Work Order ID 99347

Item Name: Crosstube Aft

DART AEROSPACE LTD		Work Order:	99347
Description: Crosstube High Aft (205/212)		Part Number:	D212-664-201
Inspection Dwg: D212-664-241	Rev: D	Page 1 of 1

DRAWING NO. D212-664-241	TITLE CROSSTUBE ASSY (205/212 HI AFT)	REV. D	DART AEROSPACE LTD ENGINEERING ORDER		D.E.O. NO. D212-664-241-D-1	SHEET NO. SHEET 1 OF 2	SCALE NTS
DRAWN	CHECKED		MFG. APPR.		APPROVED	DE APPR.	
DATE 11.04.07	DATE 11.04.11		DATE 11.04.12		DATE 11/04/12	DATE 11.04.12

FIGURE 1: SUPPORT INSTALLATION

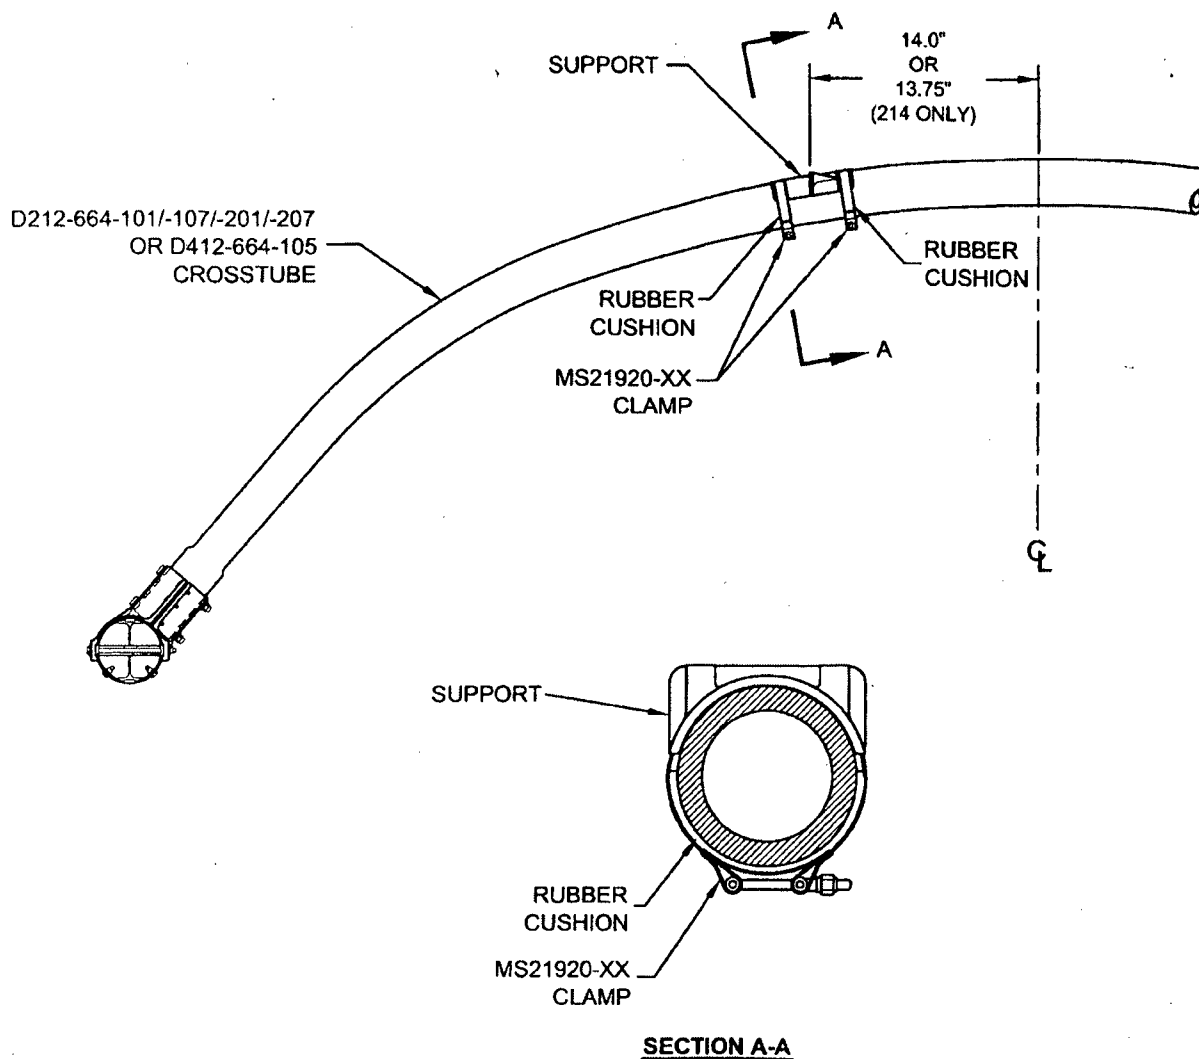
The supports on the following crosstubes are now installed using Proseal instead of Magnobond:

D212-664-101/-101B @ CHG 005	D212-664-201/-201B @ CHG 005
D412-664-105 @ CHG 002	D212-664-207/-207B @ CHG 002
D212-664-107/-107B @ CHG 002

For the crosstubes listed above, section 32.4 of ICA-D212-664 is amended as follows. Use Figure 1 of this service instruction and Figures 32-2 to 32-9 of ICA-D212-664 for further reference. For crosstubes of an earlier change number, it is recommended that if the supports are removed, the supports should be reinstalled using the procedure listed below.

- 32.4.1 Locate the area on the crosstube for installation of support (see Figure 1 of this service instruction). For D212-664-101/-107/-201/-207 and D412-664-105 crosstubes, the outward face of the support tabs should be 14.0" (355mm) from the crosstube center for 204/205/210/412/UH-1 aircraft. For installation on 214B/B-1 aircraft, the outward face of the support tabs should be 13.75" (349mm). Ensure paint finish of crosstube is intact; touch up as required per Chapter 5 (5.3.9) of ICA-D212-664.

- 32.4.2 If present, remove any paint/primer on bottom of supports. Abrade mating surfaces of support and crosstube with 400-grit sandpaper. Saturate a clean cloth with MEK or 4105S Wash'n'Wipe Degreaser or equivalent and wipe until there is no residue.

- 32.4.3 Ensure a layer of 3M Scotch-Weld 2216 B/A Epoxy Adhesive is on the bottom of the support. If required, either apply or touch-up support to have a 0.03" to 0.05" thick layer of adhesive over the entire mating surface. Allow supports to cure for 24 hours.

- 32.4.4 Abrade mating surfaces of support (after cure) and crosstube with 180-grit sandpaper. Saturate a clean cloth with MEK or 4105S Wash'n'Wipe Degreaser or equivalent and wipe until there is no residue.

- 32.4.5 Apply a 0.04" to 0.07" thick layer of Proseal 890 Class B or AMS-S-8802 Class B sealant underneath applicable support and install support as shown in Figure 1 of this service instruction.

- 32.4.6 Install the clamps opposite to crosstube support as shown in section A-A of Figure 1. Install rubber cushions underneath each clamp around the bottom circumference of the crosstube up to the crosstube centerline. Torque clamps 80-100 in-lb (9.0-11.3 Nm). It is acceptable to use smaller or larger sized MS21920-XX clamps than those listed in ICA-D212-664, ensure that after torquing the clamps per this instruction, the nuts are in safety but not bottomed out

- 32.4.7 Prior to installing crosstube on aircraft, allow supports to cure for 72 hours and recheck torque on clamps.

D212-664-241/-241B
ASSEMBLY DETAIL

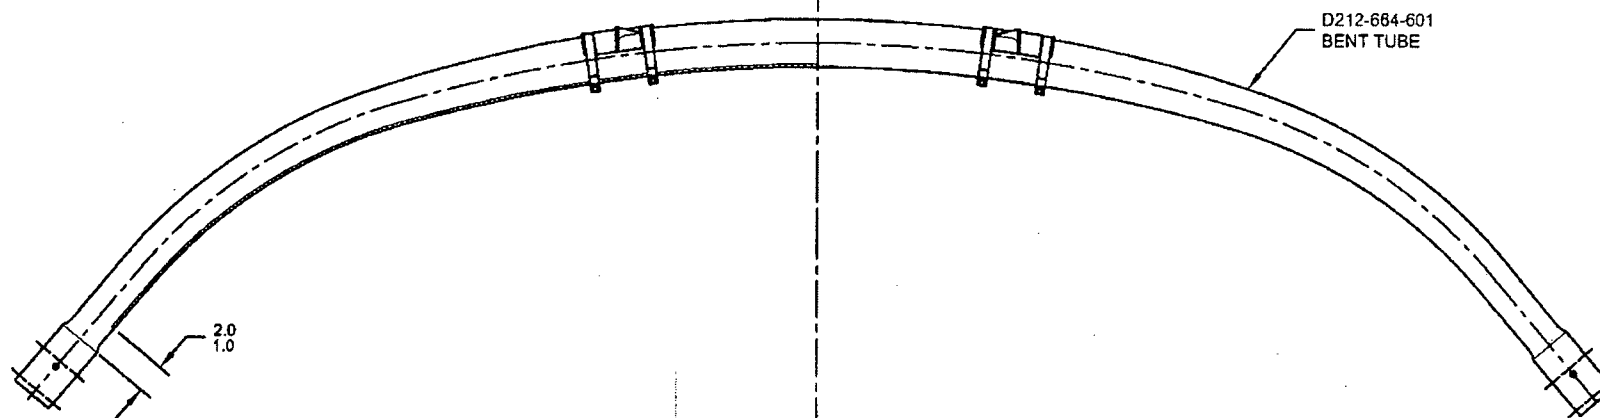
ADD AN INSPECTION WINDOW TO UNDERSIDE OF CROSSTUBE.

NOTES 2 OF SHEET 1 IS AMENDED AS FOLLOWS:

- 2) FINISH: CHEMICAL CONVERSION COAT PER DART QSI 005 4.1
PRIME INSIDE AND OUTSIDE PER DART QSI 005 4.2
MASK UNDERSIDE OF CROSSTUBE AS SHOWN (HATCHED AREA) AND
PAINT OUTSIDE PER DART QSI 005 4.2
REMOVE MASKING AND APPLY CLEAR COAT

MASK AREA PRIOR TO PAINTING,
REMOVE MASKING AFTER PAINT
AND APPLY CLEAR COAT

DRAWING NO. D212-664-241	TITLE CROSSTUBE ASS'Y (205/212 HI AFT)	REV. D	DART AEROSPACE LTD ENGINEERING ORDER		D.E.O. NO. D212-664-241-D-2	SHEET NO. SHEET 1 OF 1	SCALE NTS
DRAWN 90	CHECKED ASS	MFG. APPR. 8	APPROVED MP		DE APPR. H		
DATE 11.07.15	DATE 11.07.20	DATE 11.07.21	DATE 11/07/21		DATE 11.07.21

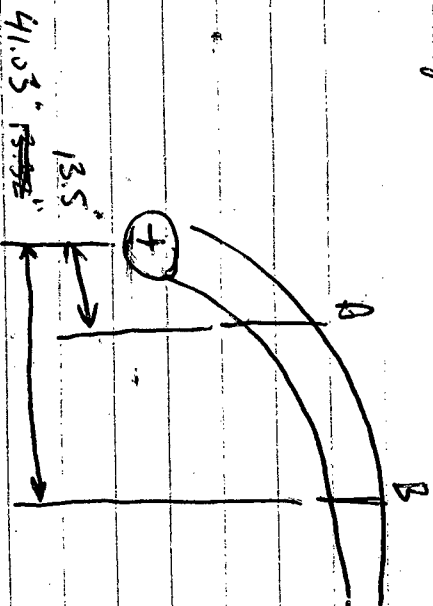
REPLACE MAGNOBOND WITH PROSEAL.

NOTE 12 & 15, SHEET 1 IS AMENDED AS FOLLOWS:

- 12) TO INSTALL D2940-1 SUPPORT: ABRASE MATING SURFACE OF SUPPORT AND CROSSTUBE WITH 180-GRIT SANDPAPER AND REMOVE RESIDUE WITH MEK (OR EQUIVALENT). APPLY A 0.04" TO 0.07" THICK LAYER OF PROSEAL 890 CLASS B-2 (OR AMS-S-8802 CLASS B-2) SEALANT TO MATING SURFACE OF SUPPORT.
- 15) TORQUE CLAMPS 80 TO 100 IN-LB. ENSURE AT LEAST 1.5 THREADS SHOWING IN SAFETY AND THAT NUT HAS NOT BOTTOMED-OUT AFTER TORQUING. **PRIOR TO PACKAGING, RE-CHECK TORQUE ON CLAMPS AFTER PROSEAL 890 SEALANT HAS CURED FOR 72 HOURS.**

- 12) INSTALL D2940-1 SUPPORT USING 0.03" TO 0.06" THICK LAYER OF MAGNOBOND 6398 TO THE SURFACE OF D2940-1 THAT WILL BE IN CONTACT WITH THE CROSSTUBE PER QSI 015. LET CURE FOR 12 HOURS AFTER INSTALLATION AND PRIOR TO PACKAGING.
- 15) TORQUE CLAMPS 80 TO 100 IN-LB. ENSURE AT LEAST 1.5 THREADS SHOWING IN SAFETY AND THAT NUT HAS NOT BOTTOMED-OUT AFTER TORQUING.
